Implementation of V-Lock cord retaining feature as standard.

Product Change Notification					PCN 5123 with V-Lock		
owner	creation date	release date	released by	change order no	rev	page	D10-006-438
sariogar	04.06.2018	11.06.2018	blumhe	2015515	B	1 of 2

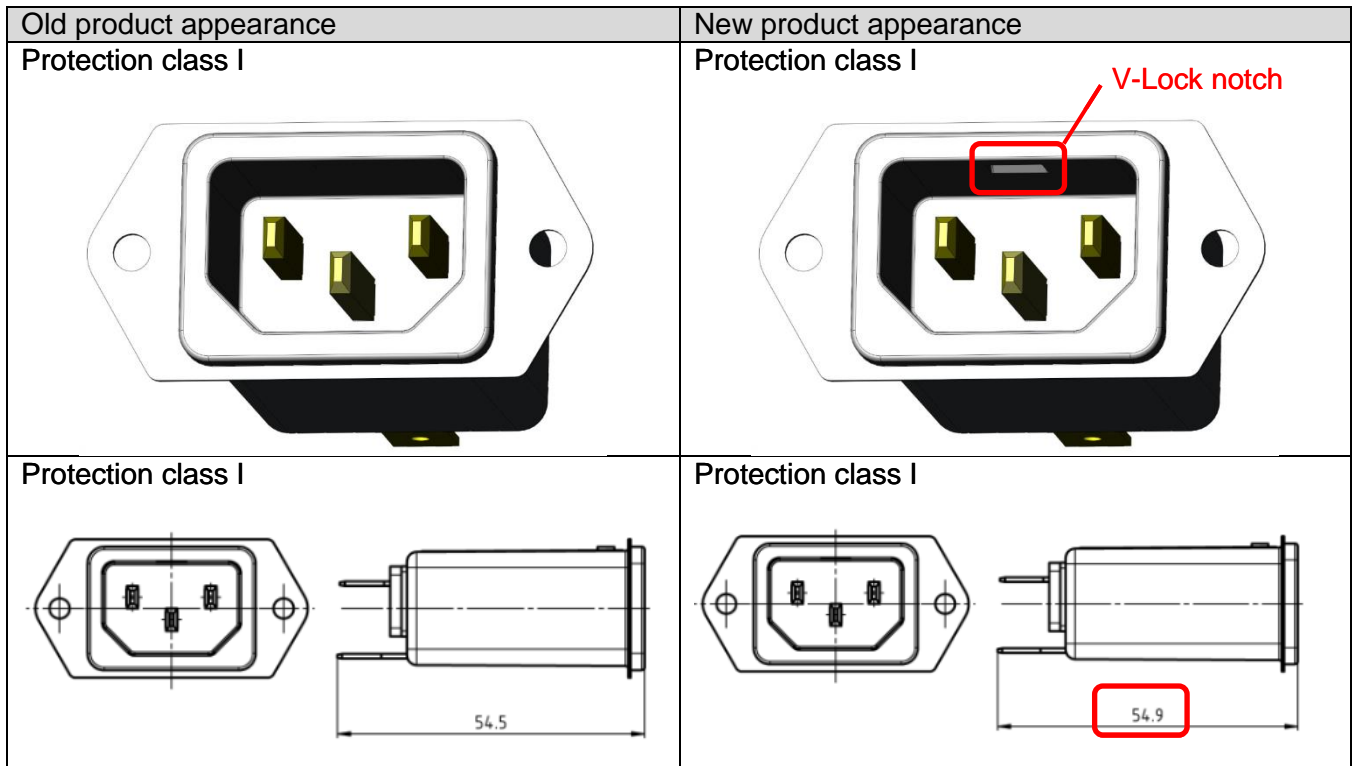
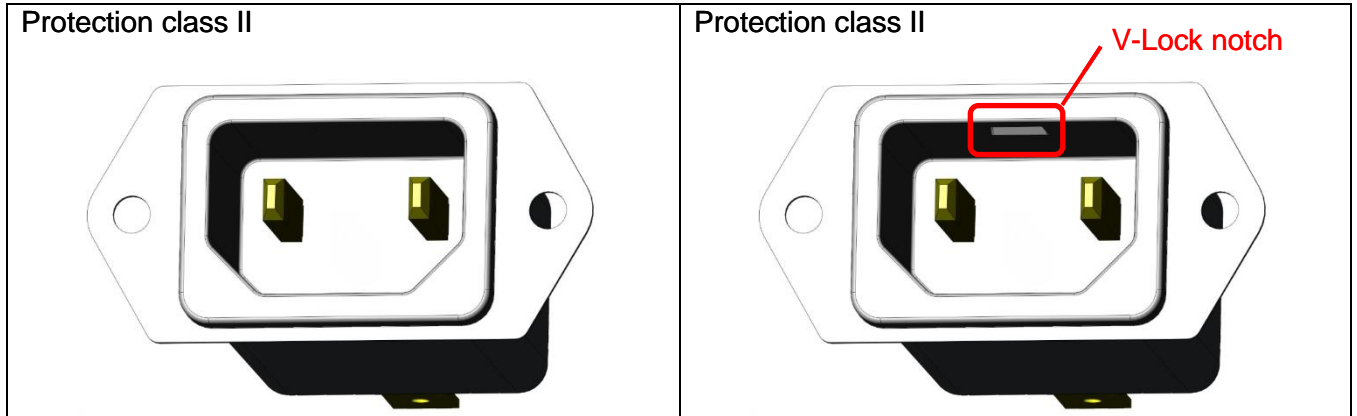
V-Lock feature integrated as standard (not an option anymore) .

Form	Yes	Socket has notch for V-Lock cord
Fit	Yes	Installation depth is 0.40 mm extended
Function	Yes	V-Lock feature is standard (not an option anymore)
Production Site	No	There is no change of the production site
Product Label	No	There is no change on the label

As the V-Lock will be standard feature, the material numbers with index .21 will be obsolete and will be replaced by the standard numbers. Please order according to the data sheet.

5123.0004.0.21	⇒	5123.0004.0	5123.1007.0.21	⇒	5123.1007.0
5123.2000.0.21	⇒	5123.2000.0	5123.1300.0.21	⇒	5123.1300.0
5123.1000.0.21	⇒	5123.1000.0	5123.1301.0.21	⇒	5123.1301.0
5123.1001.0.21	⇒	5123.1001.0	5123.1303.0.21	⇒	5123.1303.0
5123.1003.0.21	⇒	5123.1003.0	5123.1304.0.21	⇒	5123.1304.0
5123.1004.0.21	⇒	5123.1004.0	5123.1306.0.21	⇒	5123.1306.0
5123.1006.0.21	⇒	5123.1006.0	5123.1307.0.21	⇒	5123.1307.0
